SVT-CL AND
SVT-2PRD

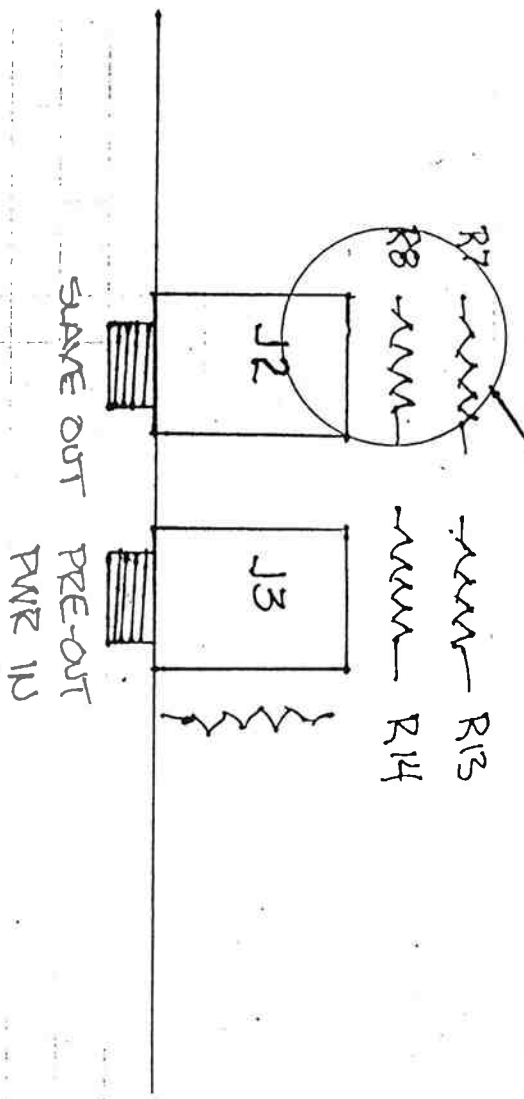
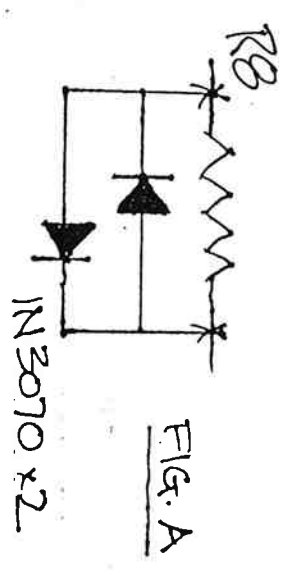
ADD (2) IN3070 (21A370-01) DIODES
BACKWARDS FROM EACH OTHER IN
PARALLEL WITH R8 (FIG. A)
